State of New Mexico  
Energy, Minerals and Natural Resources

Form C-103  
Revised July 18, 2013

SUNDRY NOTICES AND REPORTS ON WELLS  
(DO NOT USE THIS FORM FOR PROPOSALS TO DRILL OR TO DEEPEN OR PLUG BACK TO A DIFFERENT RESERVOIR. USE "APPLICATION FOR PERMIT" (FORM C-101) FOR SUCH PROPOSALS.)

WELL NAME: State CO Com # 4

**Before****Tops:**

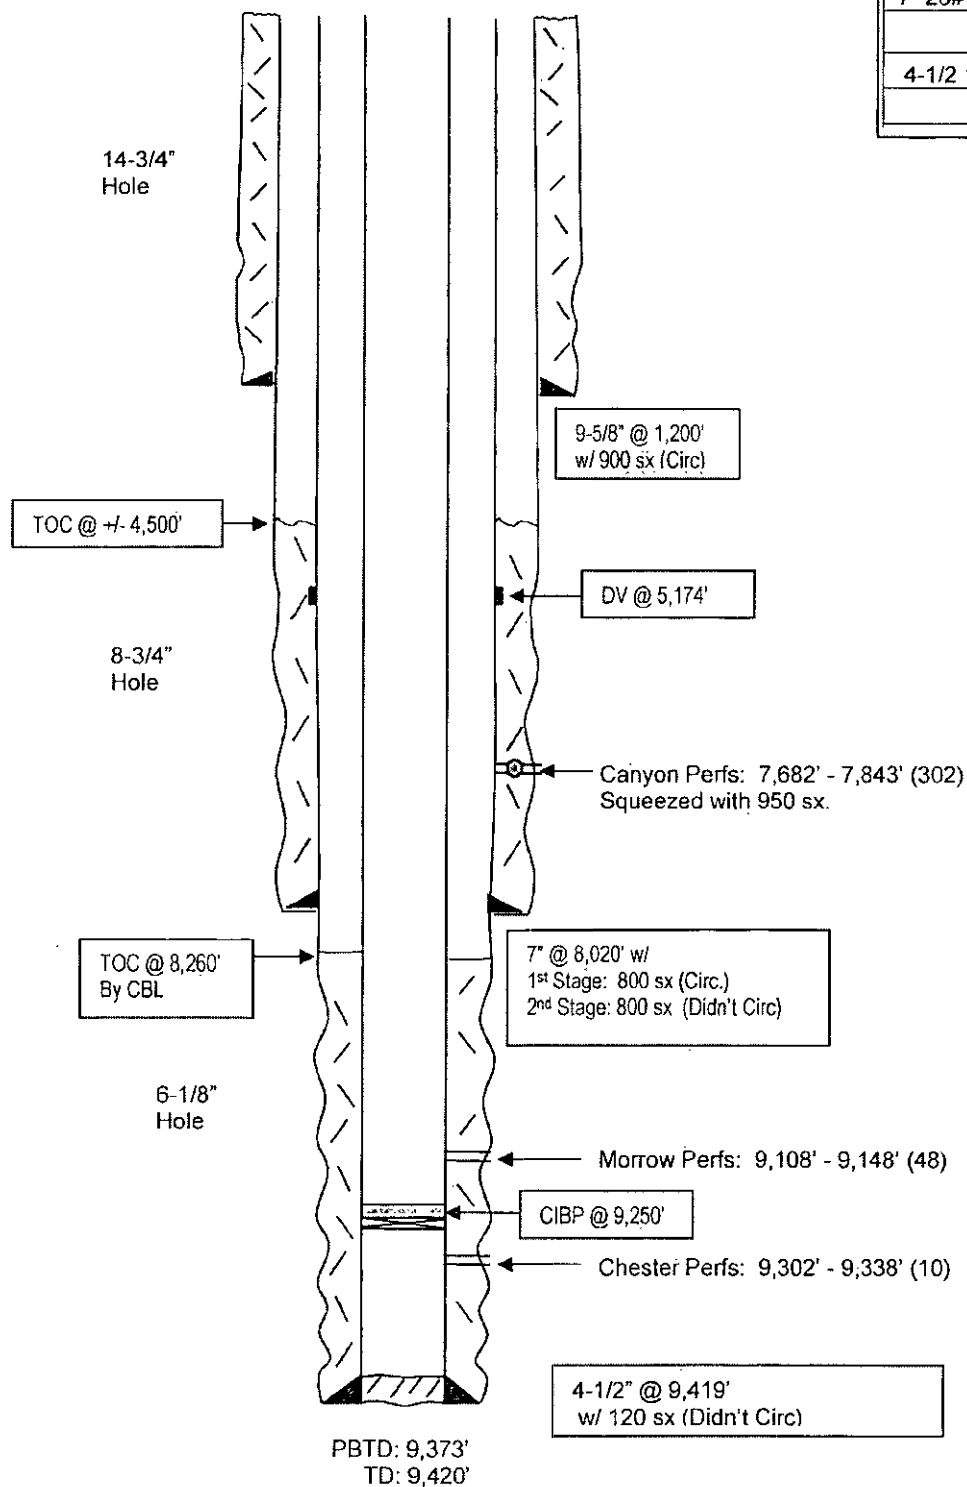
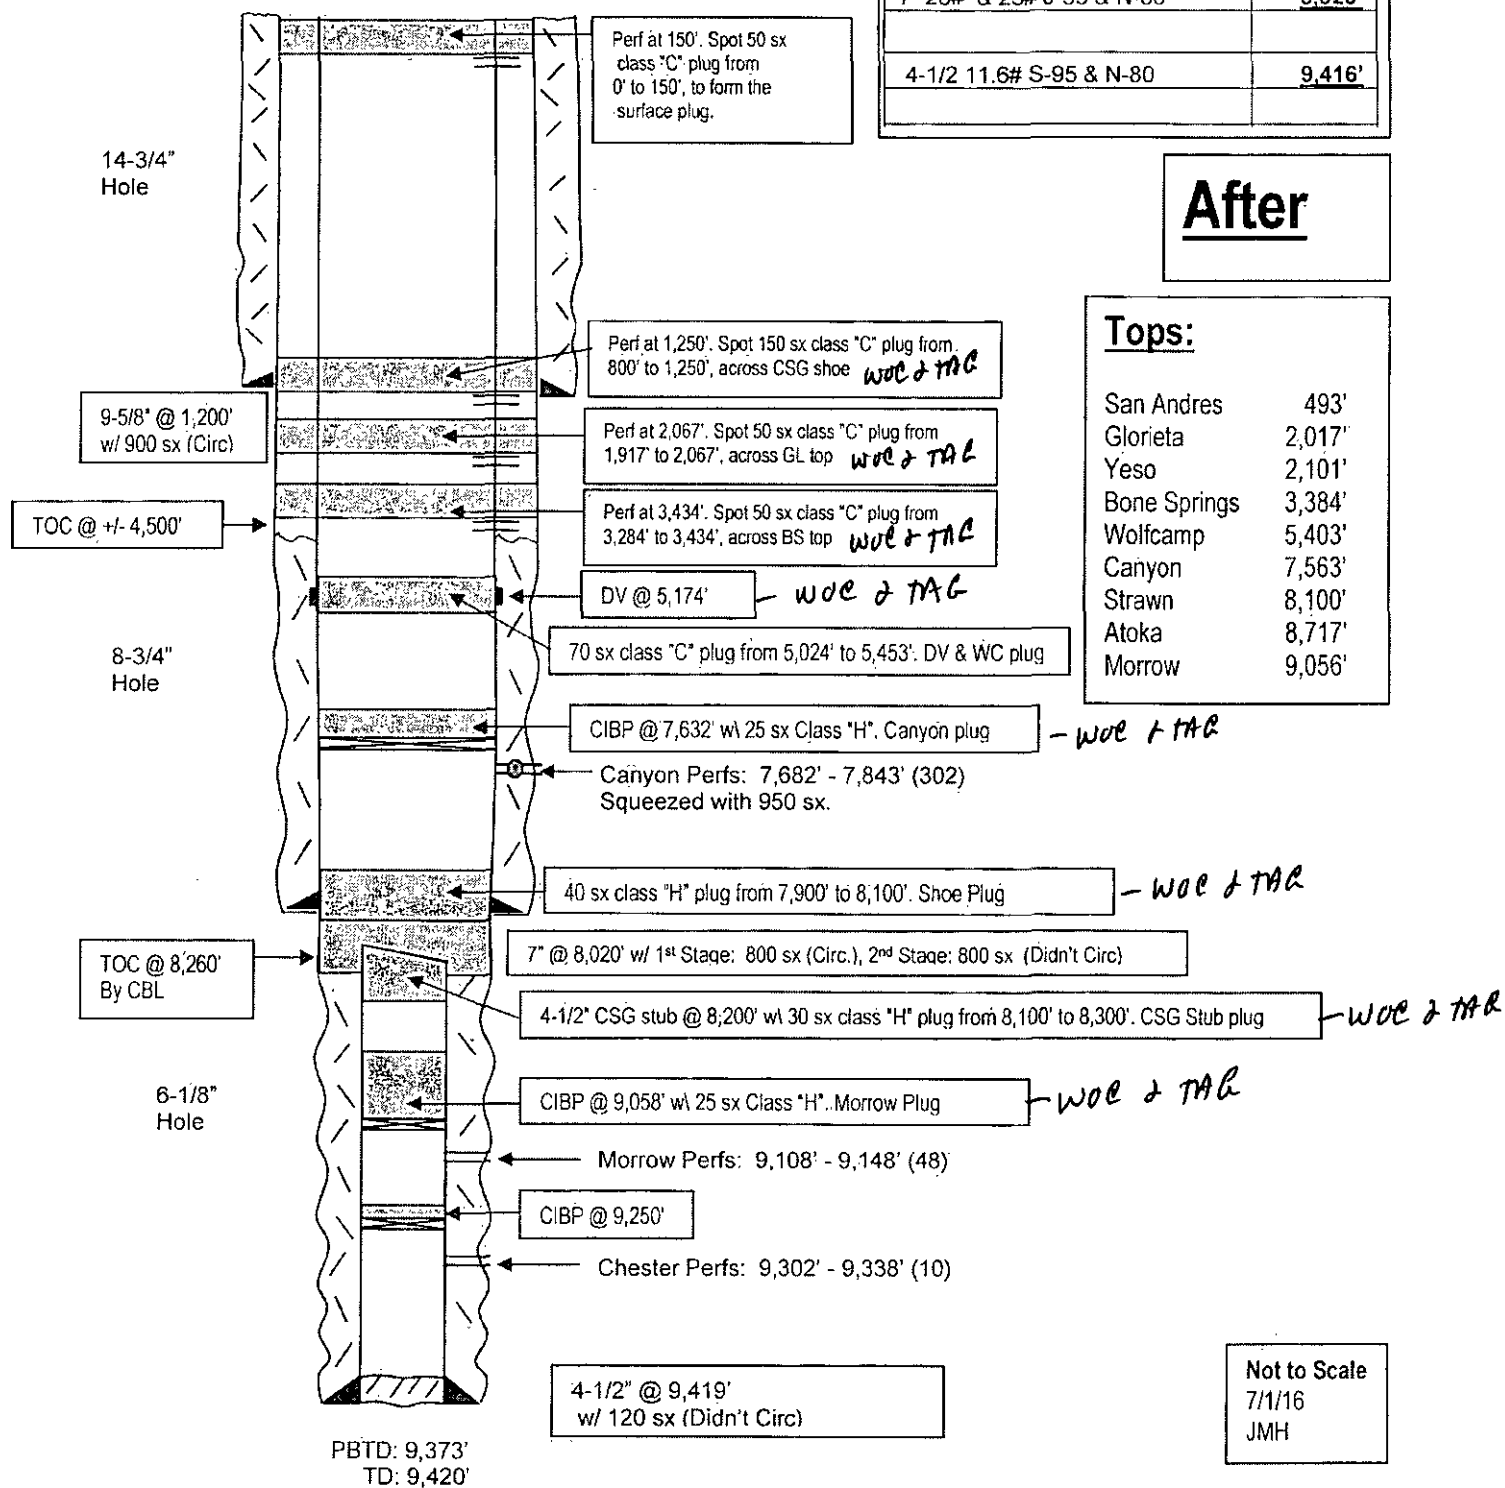
3. Load hole with ~~fresh water~~ and cut 4-1/2" casing at +/-8200'. Spot a 30 sx Class "H" cement plug from 100' inside the casing stub to 100' above the casing stub. This should be at +/-8100'-8300' depending on where the casing actually parts. WOC and tag.

4. Load hole with plugging mud. Spot a 40 sx Class "H" cement plug from +/-7900'-8100'. This will leave a plug across casing shoe. WOC and tag.
5. Set a CIBP at 7632' and cap it with 25 sx Class "H" cement. This will place a plug over the squeezed Canyon perms. - WOC & TAG
